Item Name: Fwd Crosstube - High 407

DART AEROSPACE LTD		Work Order:	139863
Description: Crosstube High Fwd (407)		Part Number:	D407-667-105
Inspection Dwg: D407-667-145 Rev: C		Page 1 of 1

DRAWING NO. D407-667-145	TITLE CROSSTUBE ASS'Y (407 HIGH FWD)	REV. C	DART AEROSPACE LTD ENGINEERING ORDER		D.E.O. NO. D407-667-145-C-1	SHEET NO. SHEET 1 OF 1	SCALE NTS
DRAWN <i>47</i>	CHECKED <i>ASS</i>	MFG. APPR. <i>18</i>	APPROVED <i>WD</i>		DE APPR. <i>11</i>		
DATE 11.07.15	DATE 11.07.22	DATE 11.07.22	DATE 11/07/22		DATE 11.07.21

DRAWING NO. D407-667-145	TITLE CROSSTUBE ASS'Y (407 HIGH FWD)	REV. C	DART AEROSPACE LTD ENGINEERING ORDER		D.E.O. NO. D407-667-145-C-2	SHEET NO. SHEET 1 OF 1	SCALE NTS
DRAWN AJS	CHECKED [Signature]	MFG. APPR. [Signature]	APPROVED [Signature]		DE APPR. [Signature]		
DATE 12.08.02	DATE 12.08.02	DATE 12.08.02	DATE 12.08.02		DATE 12.08.02

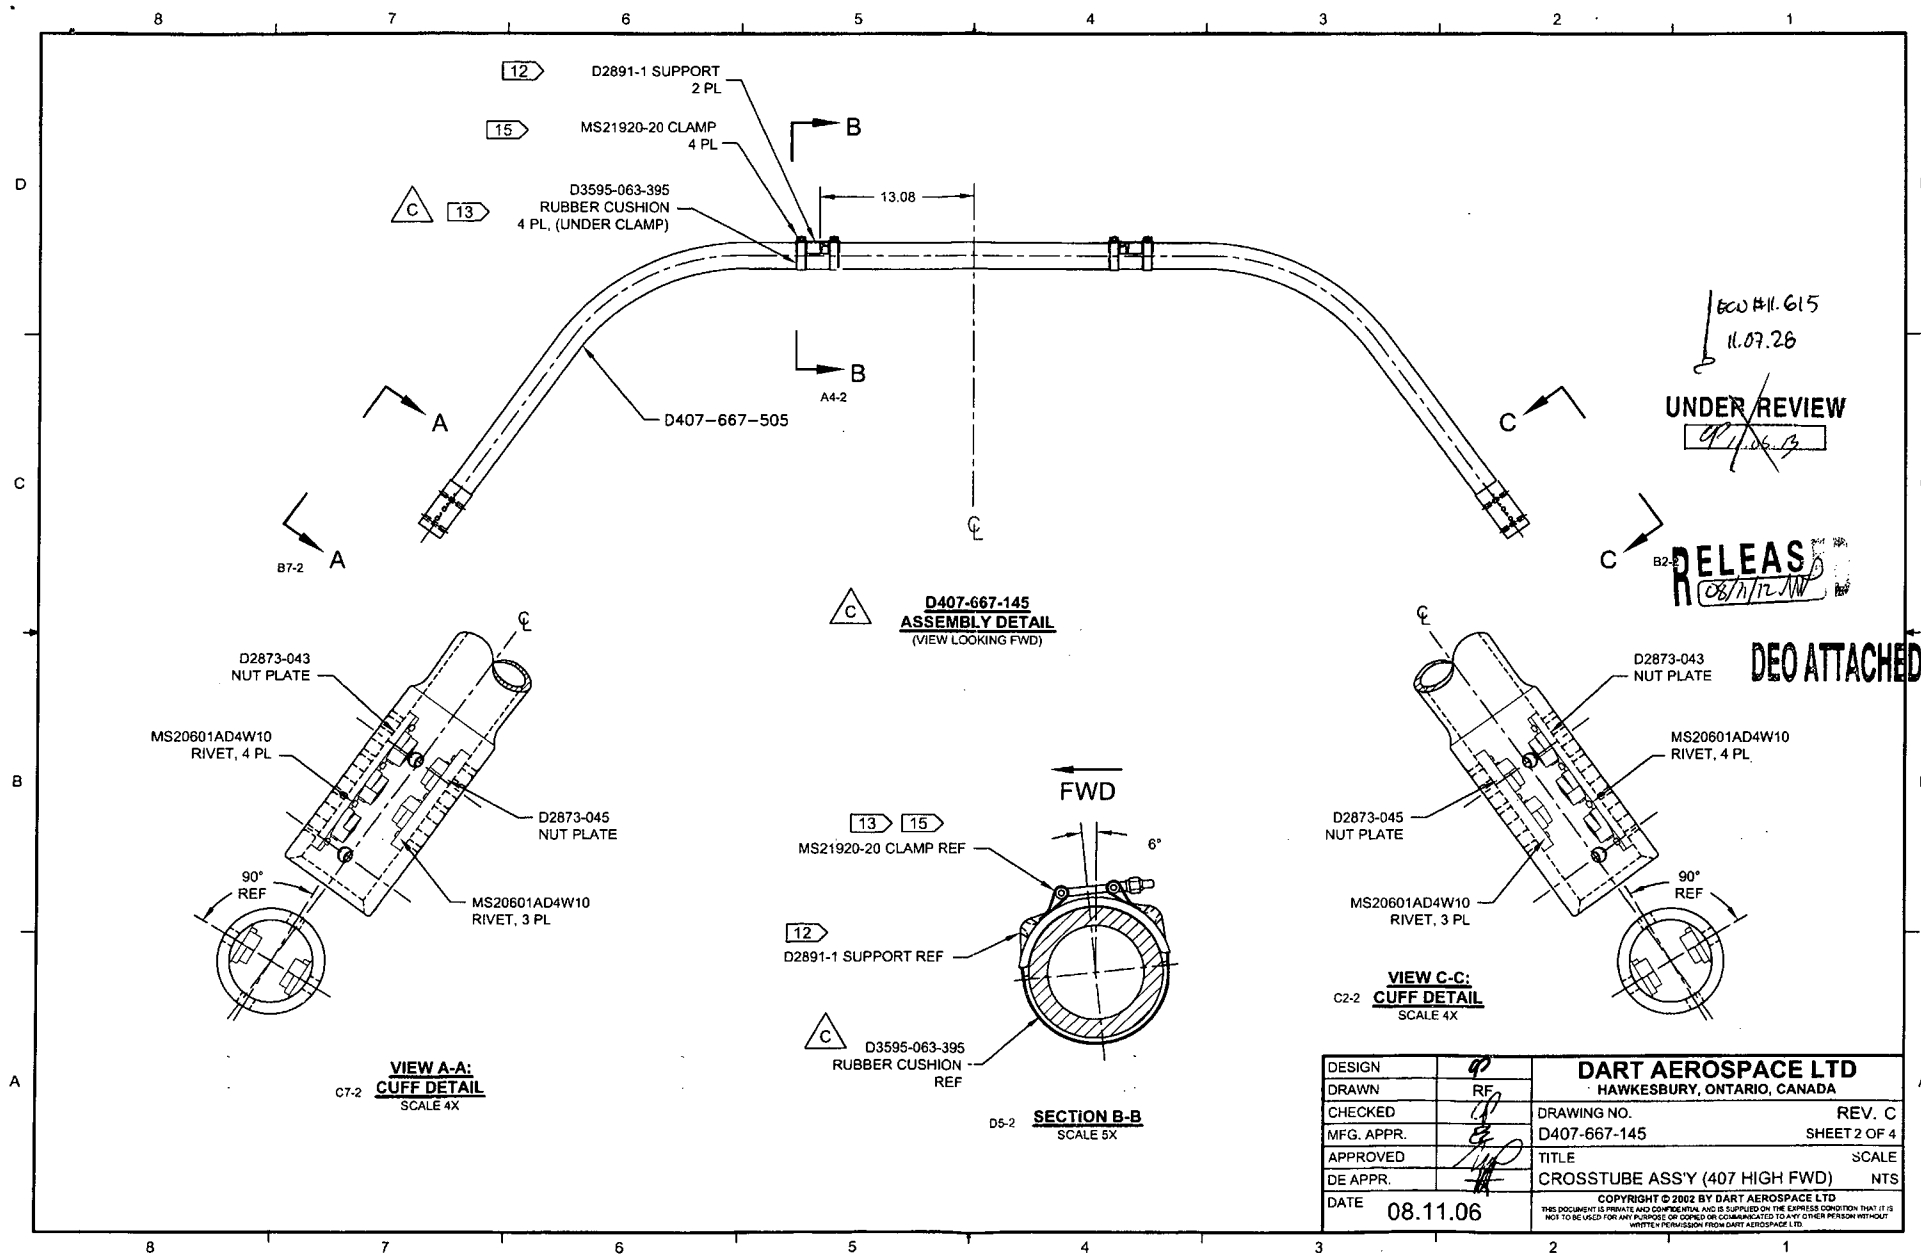
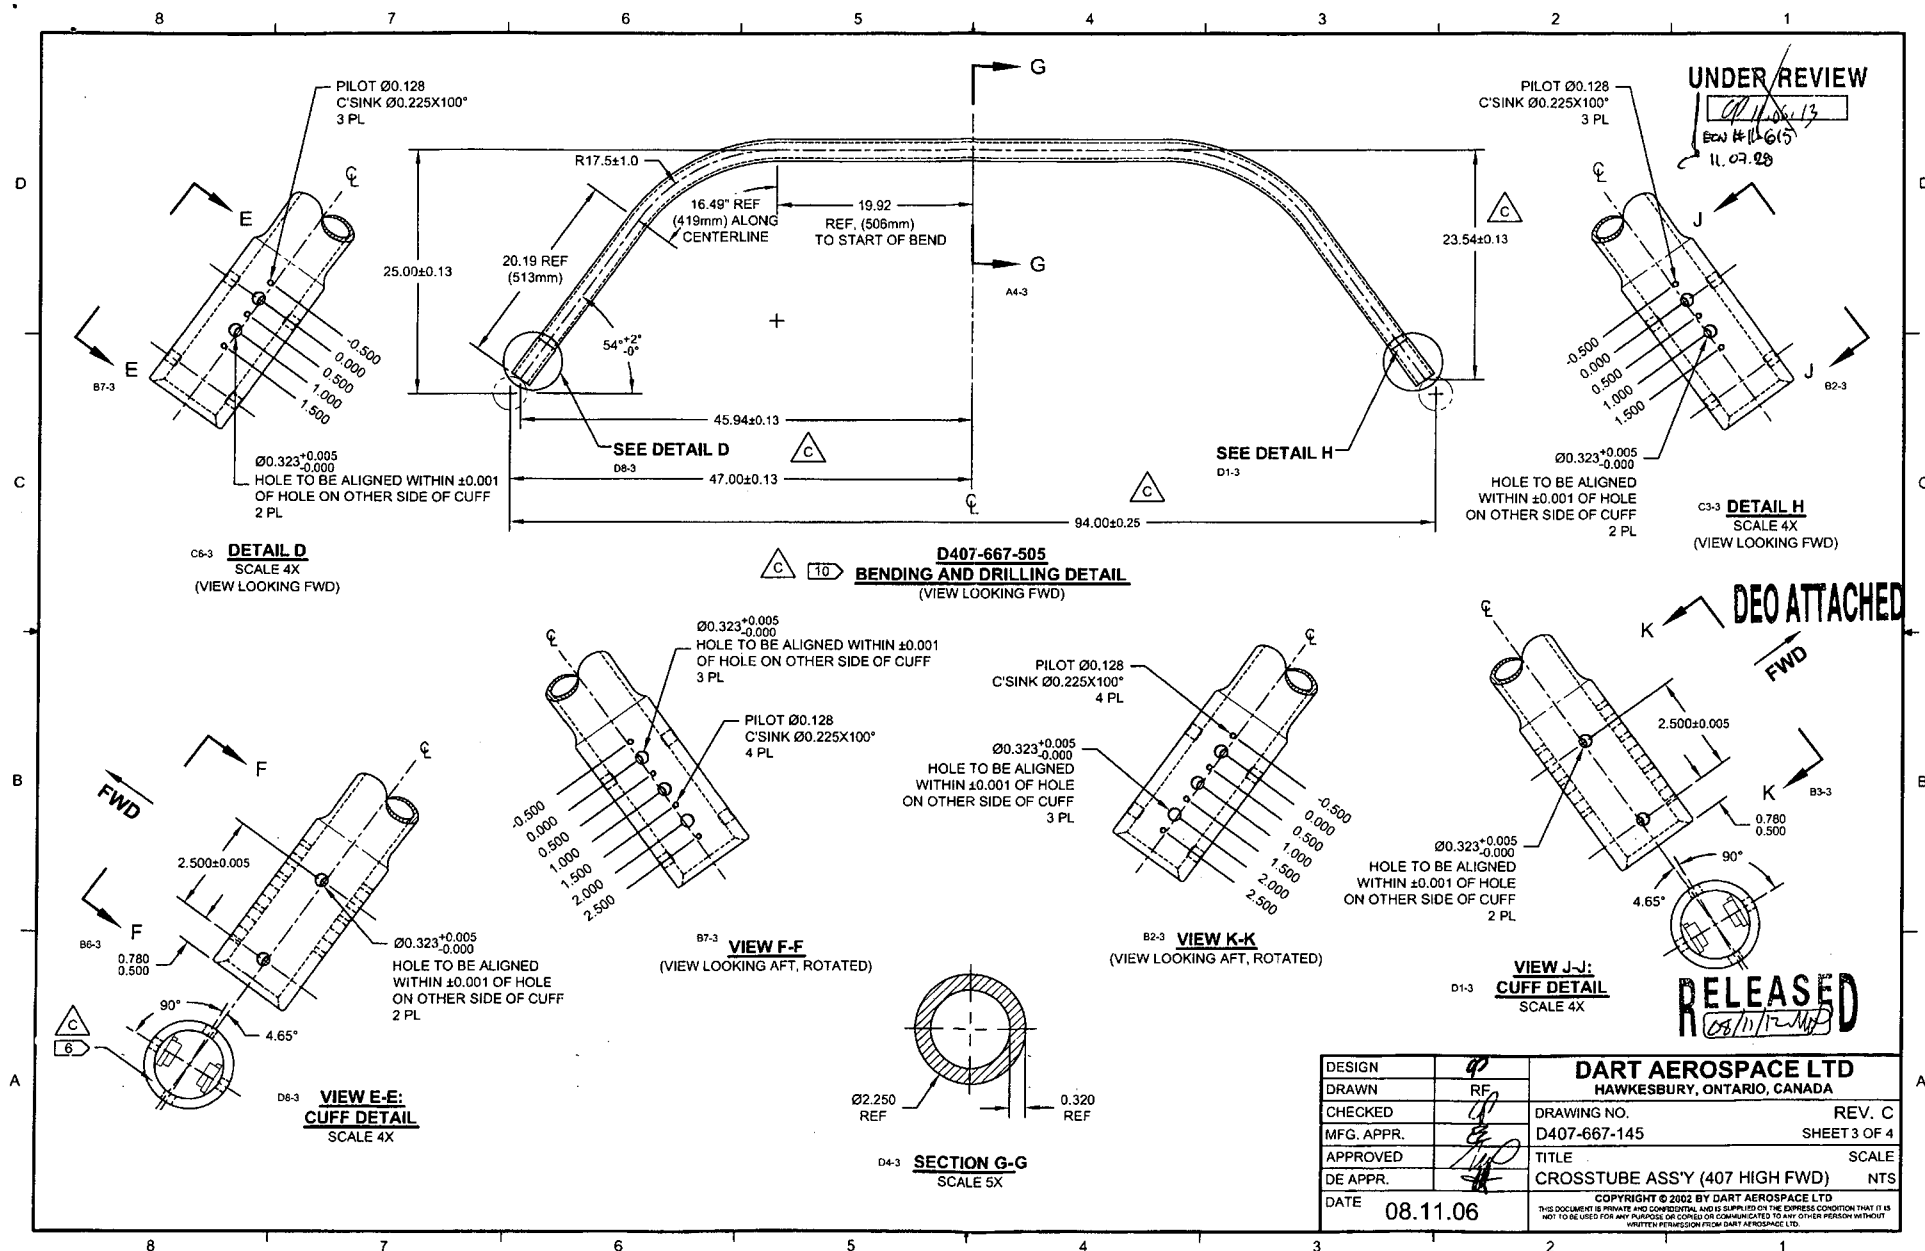
DEO ATTACHED

DETAIL P
BONDING STRAP INSTALLATION 2 PL

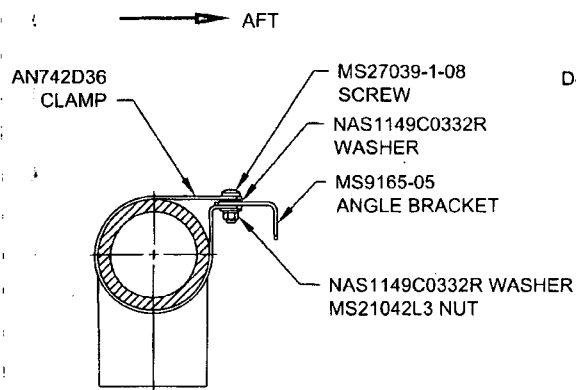
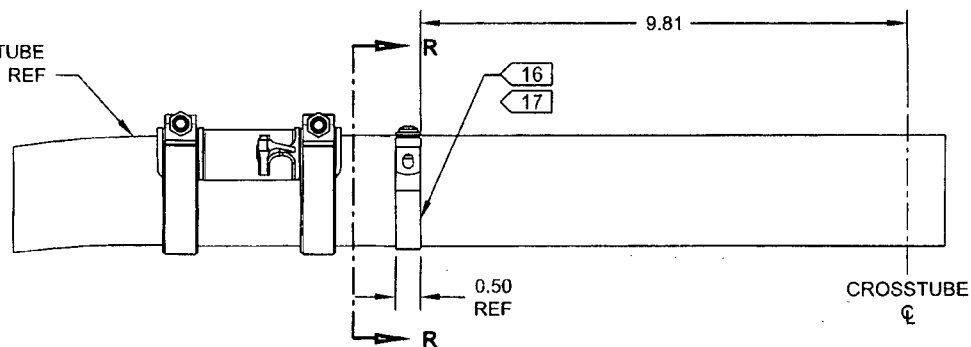
ADD ELECTRICAL GROUNDING STRAP

ITEM	QTY -145	PART NUMBER	DESCRIPTION
1	X	D407-667-145	CROSSTUBE ASSEMBLY (407 HIGH FWD)
⚡			
10	2	AN742D36	CLAMP
11	2	MS9165-05	ANGLE BRACKET
12	2	MS21042L3	NUT (OR MS21042-3)
13	2	MS27039-1-08	SCREW
14	4	NAS1149C0332R	WASHER (OR AN960C10L)

RELEASED
CP 12.08.17
ECN 12-631
